**REQUEST**

Current Zoning: NC (neighborhood center), N1-D (neighborhood 1 - D), and O-6(CD) (office, conditional)  
Proposed Zoning: CAC-1 (EX) (community activity center 1, exception)

Approximately 2.839 acres bound by the south side of Central Avenue, west side of Piedmont Street, north side of Sunnyside Avenue, and east side of the Independence/I-277 Ramp.

Staff recommends approval of this petition upon resolution of a requested technical revision.

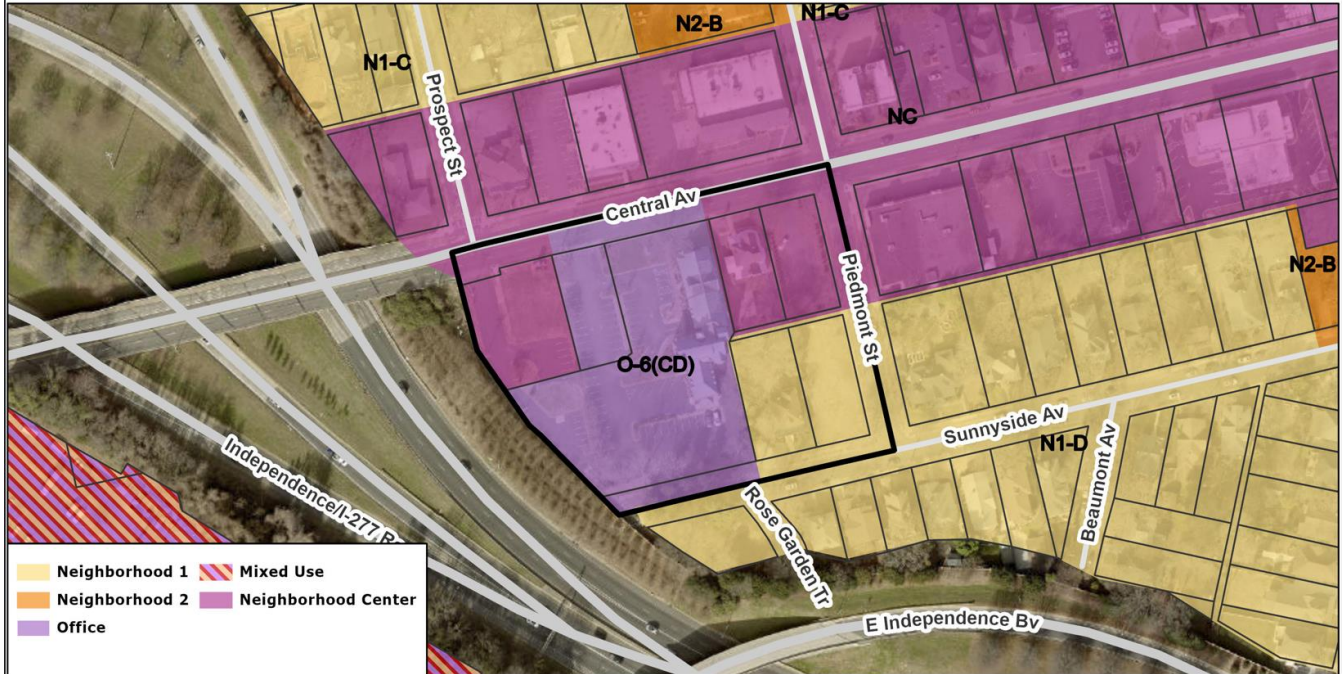
1. Revise the site plan to clearly show the limits of CATS infrastructure.
